Addendum No. 2
August 26, 2022

Project name: Health Sciences Surgical Simulation Suite Renovation
University of South Dakota
Sanford School of Medicine
OSE #R0622—05X
Architecture Incorporated Project #:0217.2984.22

DOOR CARD ACCESS CONTROL DETAIL

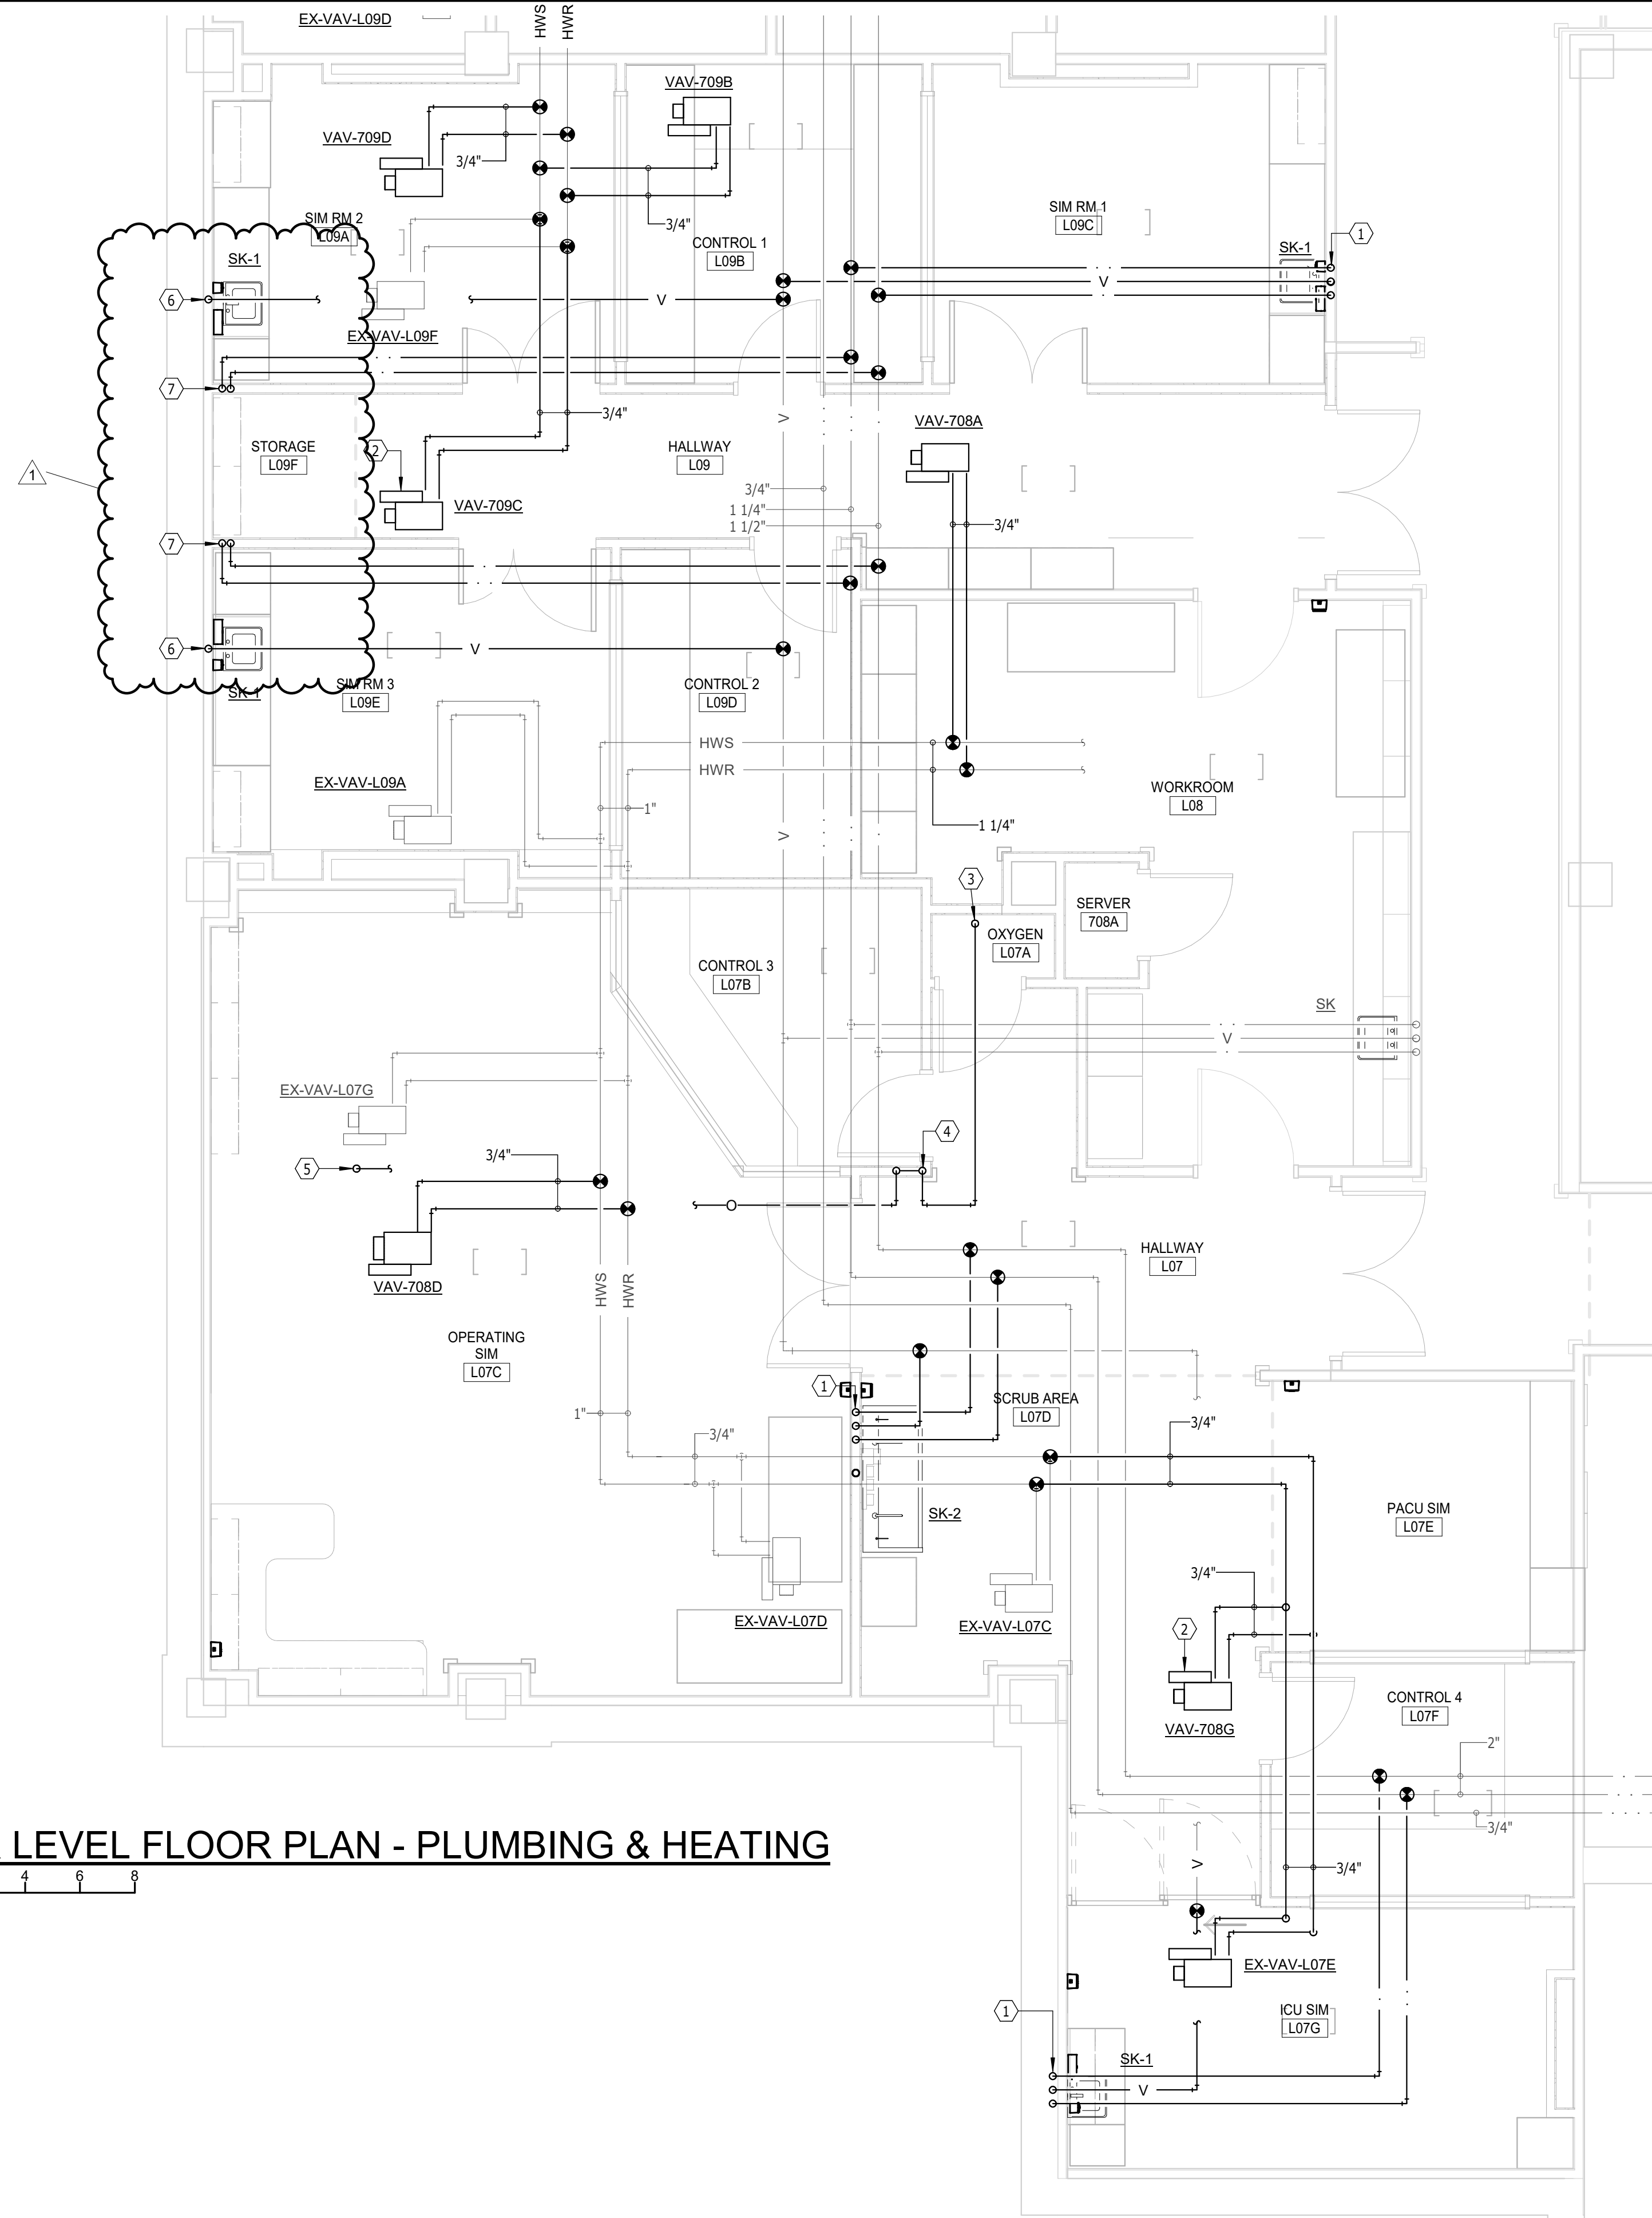
- a) **CLARIFICATION:** All new rim exit devices to have cylinder dogging. Core to be provided by owner.
 - b) **CLARIFICATION:** Single card reader device at doors L07 and L09 to control the electric strike both doors at each pair.

- i) Reference attached Door Card Access Control Details for additional information regarding rough-in installation and cabling.
 - c) Add the following information for Electric Strikes.

8.31

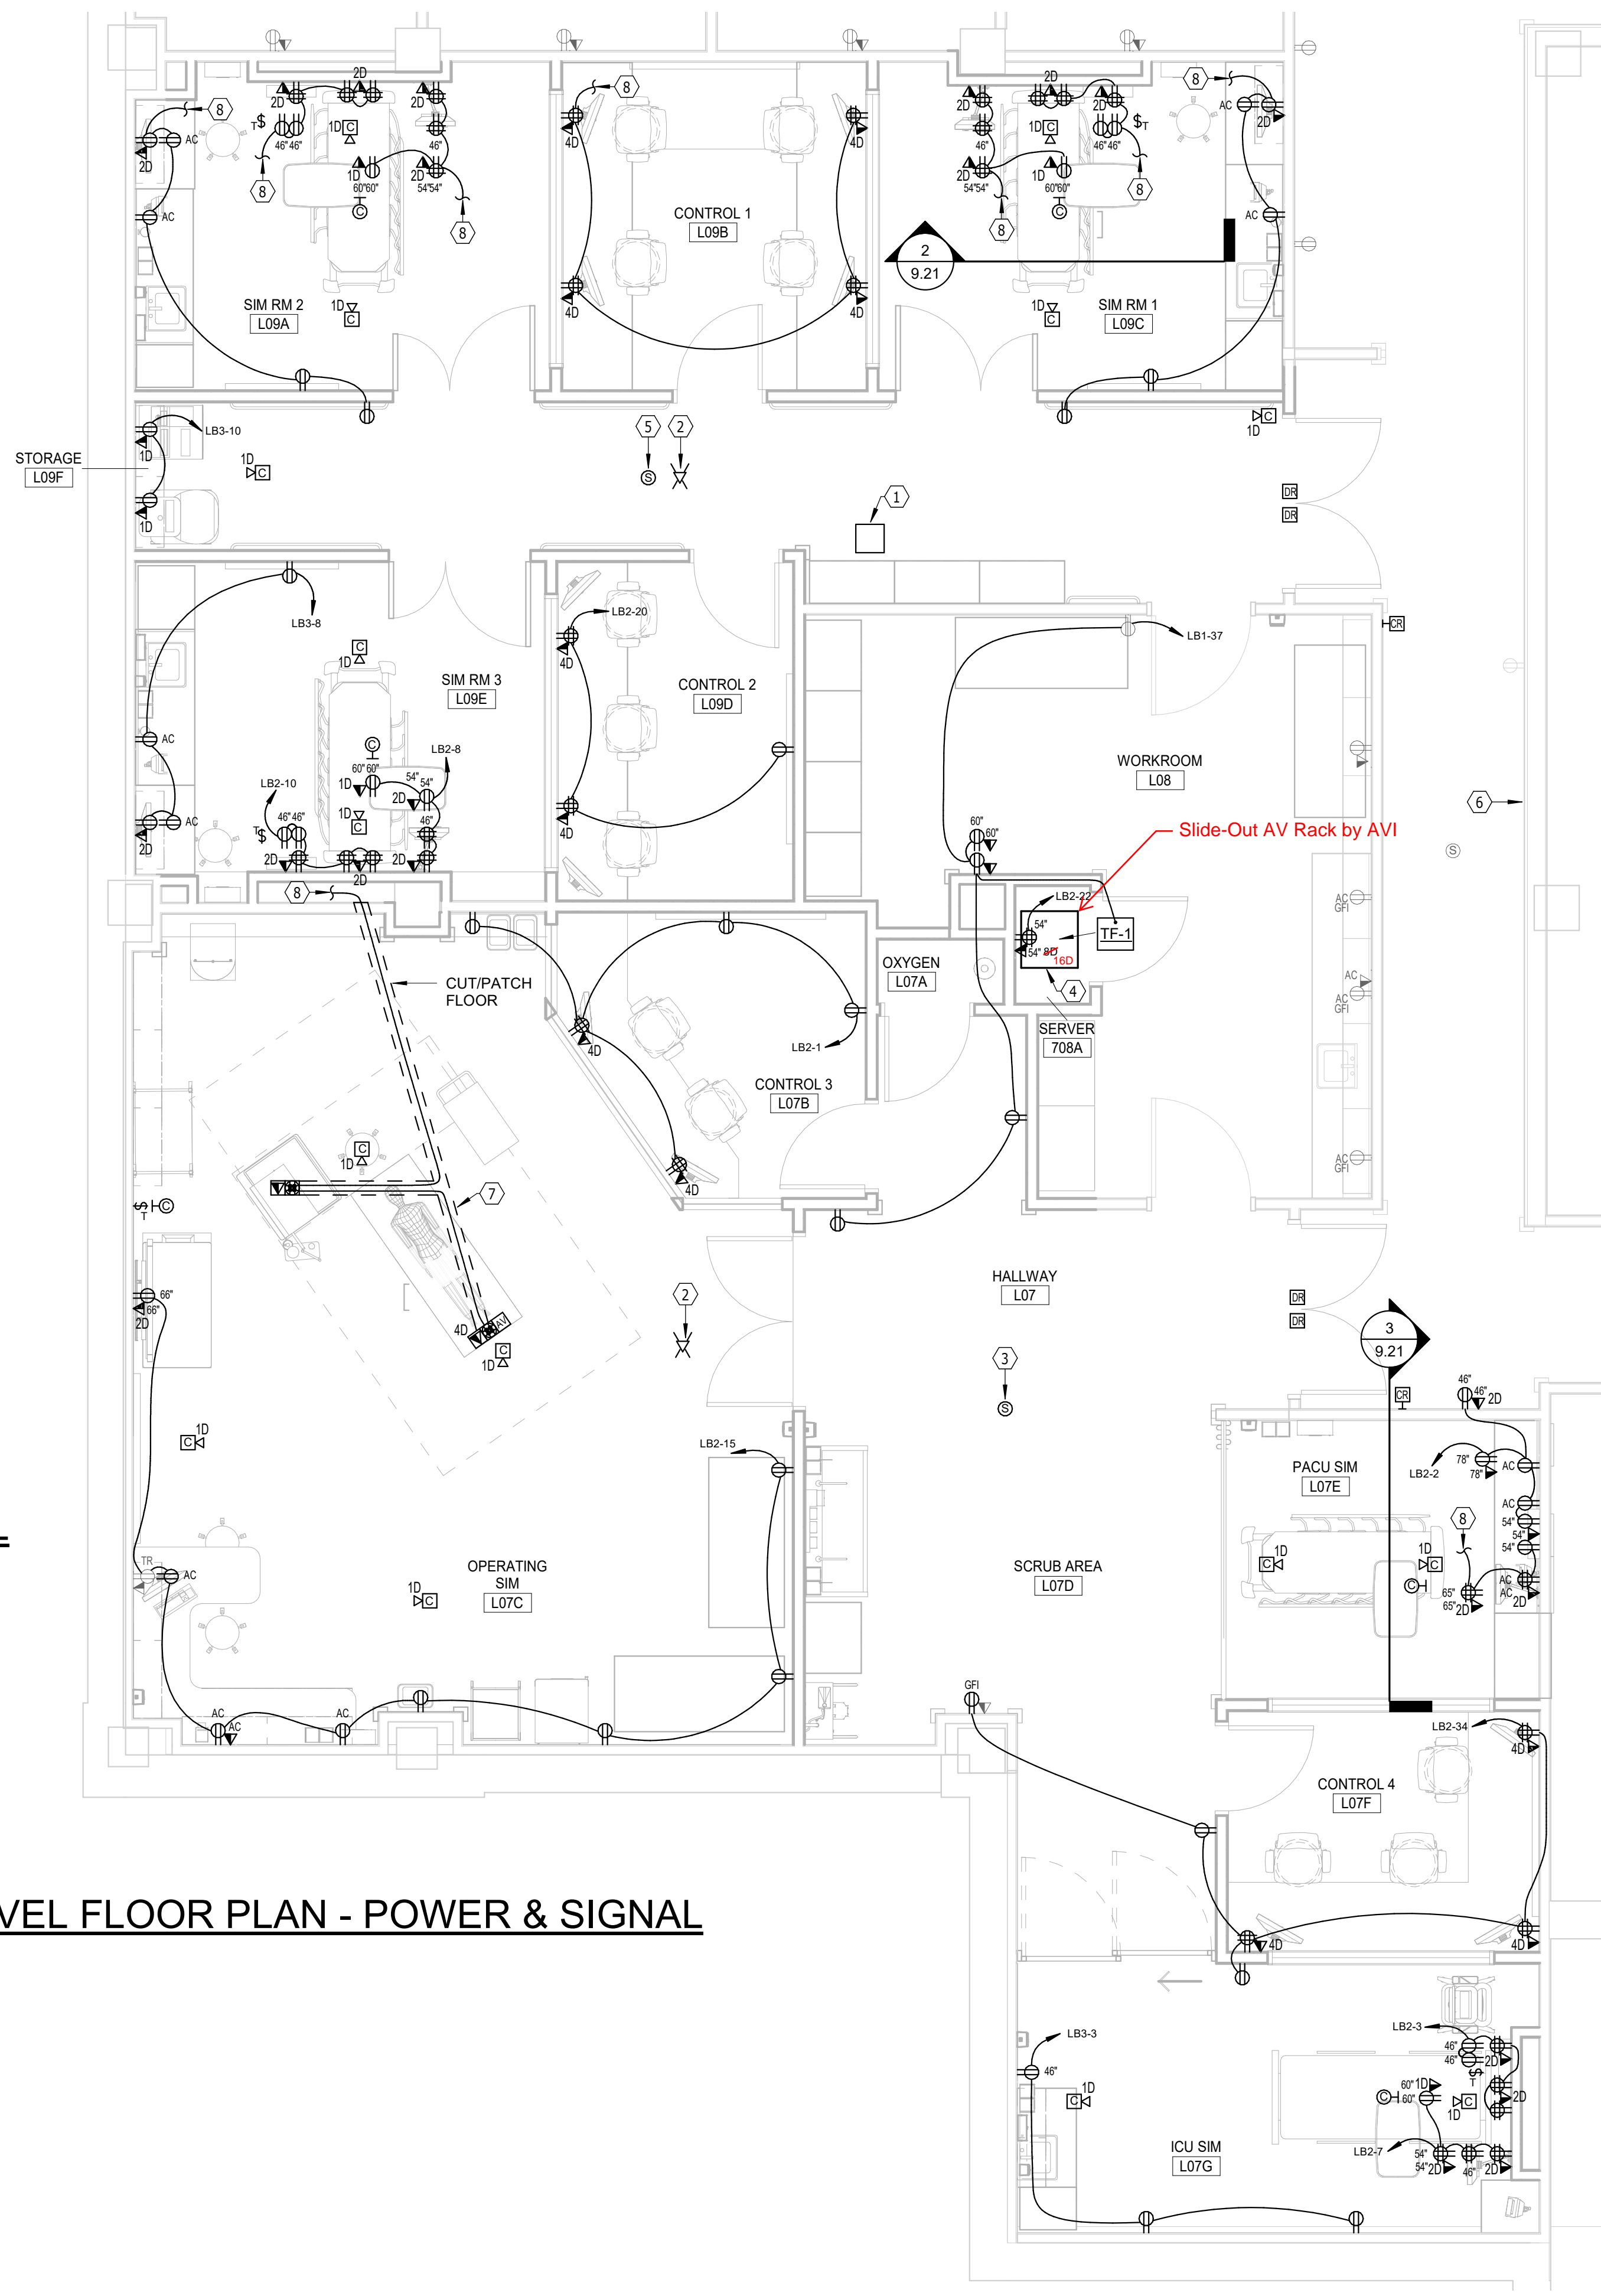
5) **DRAWING SHEET 8.31 – LOWER LEVEL FLOOR PLAN – PLUMBING & HEATING**

1. Modify piping to SK-1 in rooms L09A and L09E as shown on revision sheet 8.31, Addendum #2, dated 8-26-22.
2. Add Plumbing and Heating Note 6 and 7 as shown on revision sheet 8.31, Addendum #2, dated 8-26-22.

6 1 1/2" V/2" W DN

7 1/2" HW & 1/2" CW DN. EXTEND PIPING IN TOESPACE OF CABINET TO SINK

9.21

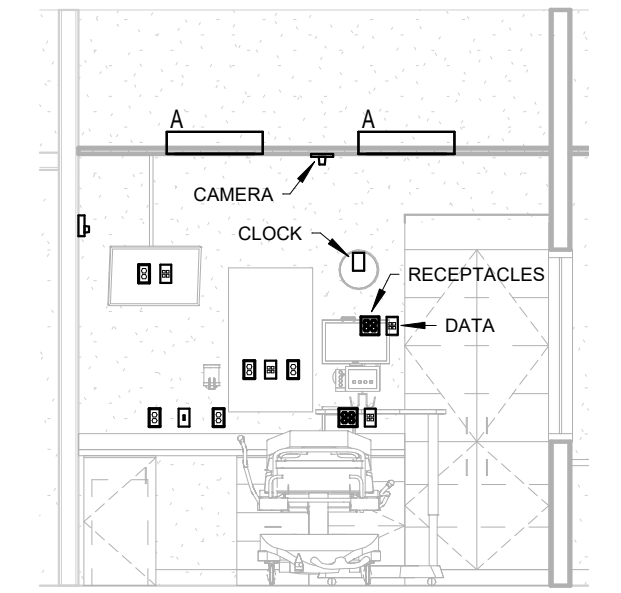
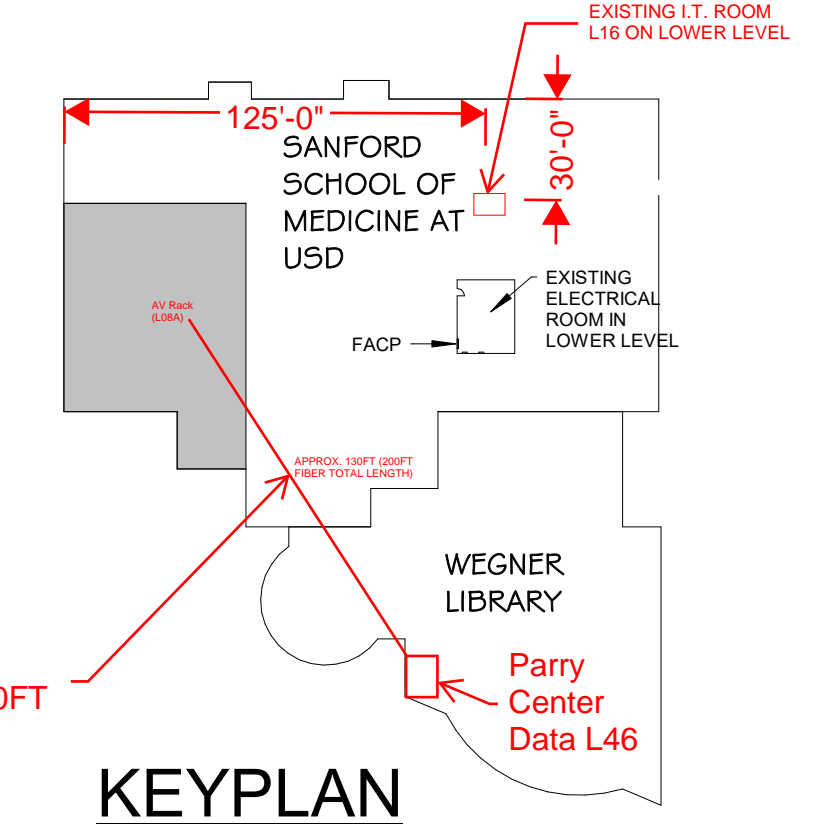
6) **ELECTRICAL DRAWING SHEET 9.21 - PARTIAL LOWER LEVEL FLOOR PLAN – POWER & SIGNAL**

1. In reference to the telecom system, provide the following modifications:
 - a. Change to Panduit Min-com connectivity and General Cable (Prysmian) Cat.6 cable.
 - b. ALL data/camera cable is to route into the existing data closet L16 in the lower level, not SERVER L08A. Room L16 is located on the north side of the northeast stairwell in the lower level (highlighted in blue below).
 - c. In Room L08A, the slide-out rack shall be provided by AVI. Provide (16D) data drops in new room SERVER L08A in lieu of (8D).
 - d. Add 12-strand MM fiber in raceway between the new room SERVER L08A and the Parry Center data room L46. Provide 20' service loops on each end – Approx. total fiber length of 200FT.

All telecom field cabling for the renovation space shall route/terminate in the rack in the existing data closet L16 in the lower level.

PROVIDE 12-STRAND MM FIBER + 20' SERVICE LOOP ON EACH END - Approx. 200FT
